## LiDAR Quality Assessment Report

UT\_OgdenValley\_2011

This data set created using LiDAR points collected from airborne surveys completed on September 23, 2011 and covers approximately 64 square miles contained in the following county(s): Weber County, Utah; Cache County, Utah; Box Elder County, Utah.

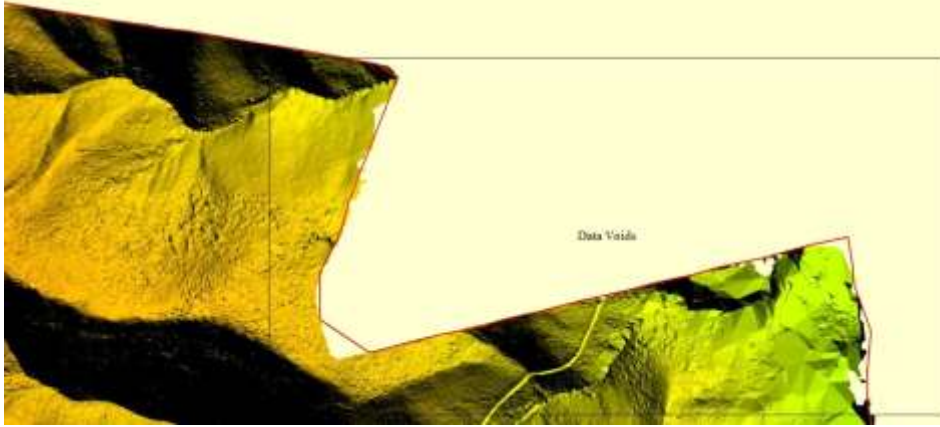
Mosaic of original DEM tiles above, some edge issues due to mismatch between the DEM and project extent.

In order to make the DEM usable in the 1/9th NED the edge issues were corrected and the project was buffered in by 100 M. This also has an accompanying DEM Project Footprint and has an area of 60.56 SqMi.

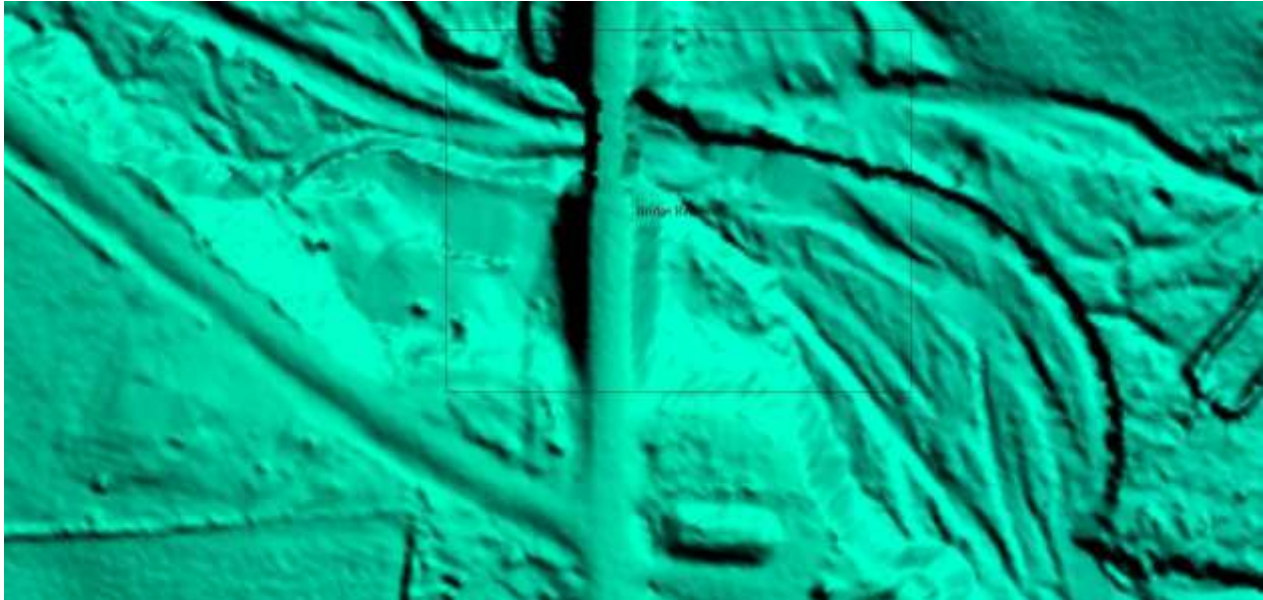
The Project extent and gridded data did not match, in order to reduce edge artifacts and data voids the final DEM was buffered in by 100 Meters.

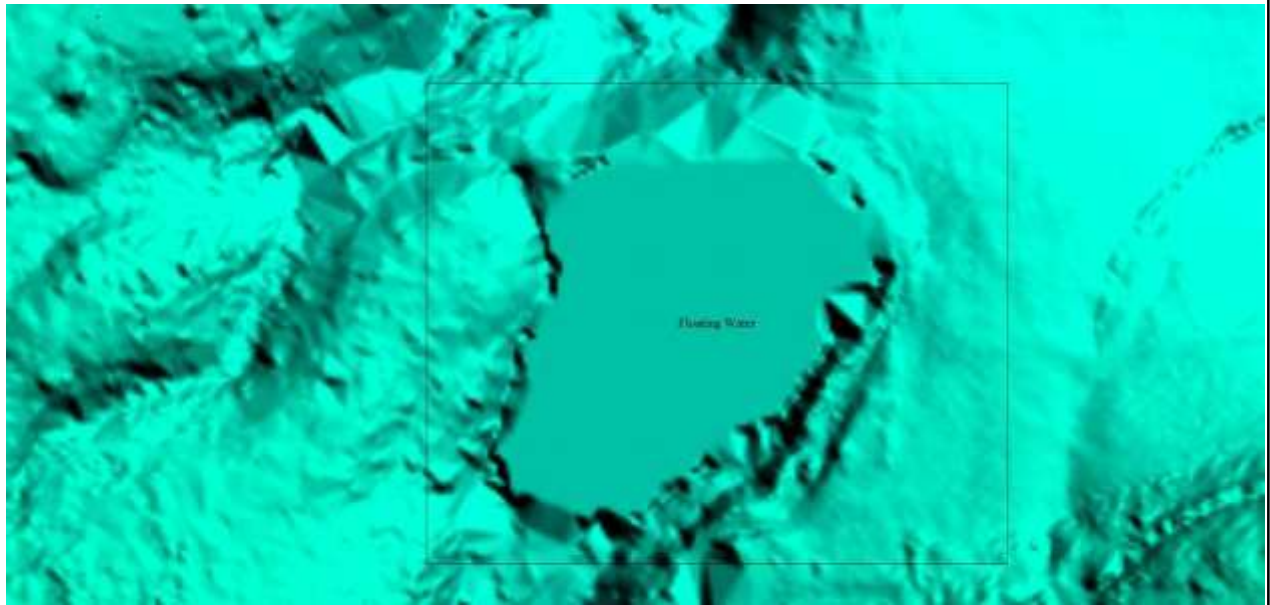
1-2 instances of bridge Removal issues.

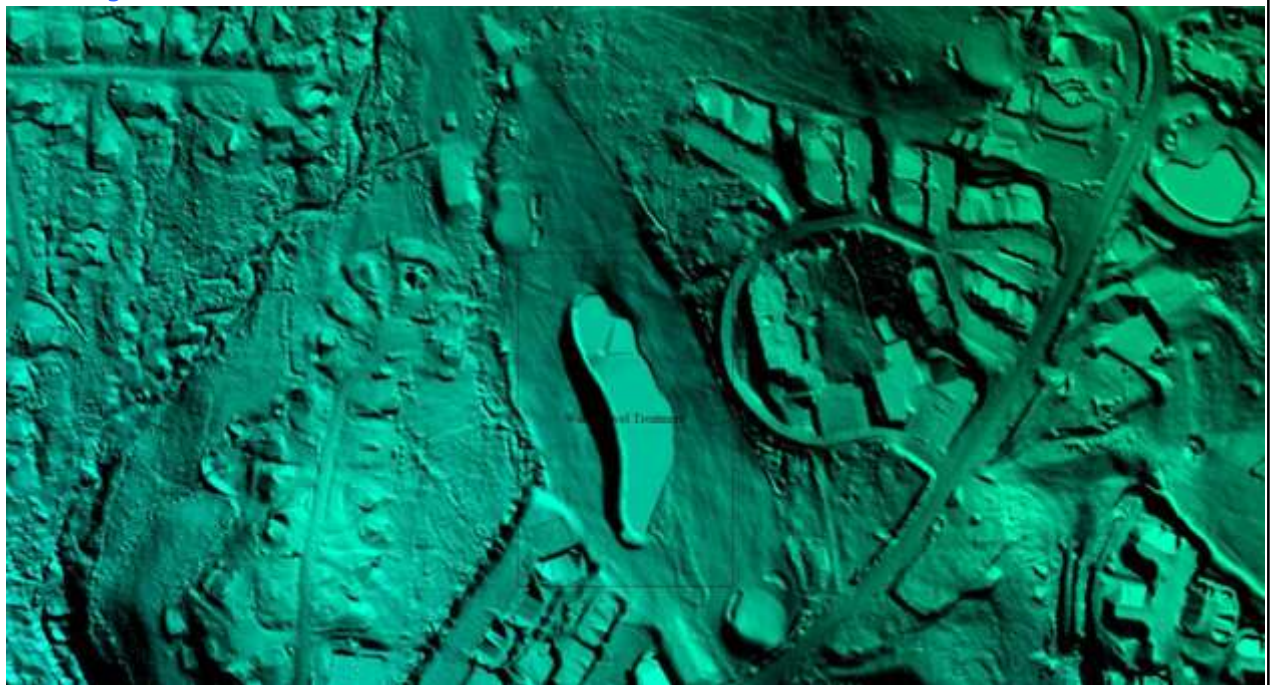
One case where water level was higher than surrounding terrain.
